Access Compliance Report

Public Rights-of-Way

(Curb Ramps)

Intersection ID: 48791	Main Street: HARDWOOD_WATCH_CT	Cross Street: WOODLAND_WATCH_CT	Location: NE
ADA ID: A501144A5609	Ramp Type: Perp	Initial Pass/Fail: Fail	Overall Compliance: No
Severity Score: 12.5			
Codes/Mitigation Info/Possible Solution		Field Measurements/Component Compliance

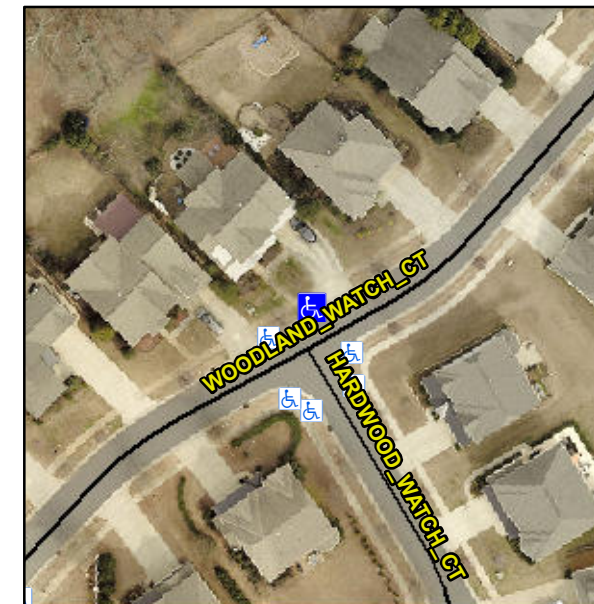
Not Found, R304.2.2

Compliance	Description	Data	Compliance	Description	Data
N/A	Ramp Length (in)	70.0	No	Ramp Slope (%)	8.9
Yes	Ramp Width (in)	48.0	Yes	Ramp XSlope (%)	1.0
N/A	Flare Type LT	N/A	N/A	Flare Type RT	N/A
N/A	Flare Slope LT (%)	N/A	N/A	Flare Slope RT (%)	N/A
N/A	Flare Traversable LT?	N/A	N/A	Flare Traversable RT?	N/A
N/A	Landing Length (in)	N/A	N/A	DWS Provided?	N/A
N/A	Landing Width (in)	N/A	N/A	DWS Contrast?	N/A
N/A	Landing Slope (%)	N/A	N/A	DWS Length (in)	N/A
N/A	Landing X Slope (%)	N/A	N/A	DWS Full Width?	N/A
N/A	Landing Curb? (Y/N)	N/A	N/A	DWS Offset (in)	N/A
N/A	Shared Landing?	N/A			
N/A	Gutter Ponding?	N/A	N/A	Gutter Slope (%)	N/A
N/A	Gutter Lip Ht (in)	N/A	N/A	Gutter X Slope (%)	N/A
N/A	Painted X Walk1?	No	N/A	Painted X Walk2?	N/A
	X Walk 1 Direction	To SE		X Walk 2 Direction	N/A
N/A	X Walk 1 Width (in)	N/A	N/A	X Walk 2 Width (in)	N/A
	X Walk 1 Slope (%)	2.8		X Walk 2 Slope (%)	N/A
	X Walk 1 X Slope (%)	0.4		X Walk 2 X Slope (%)	N/A

Remove & Replace Entire Ramp.
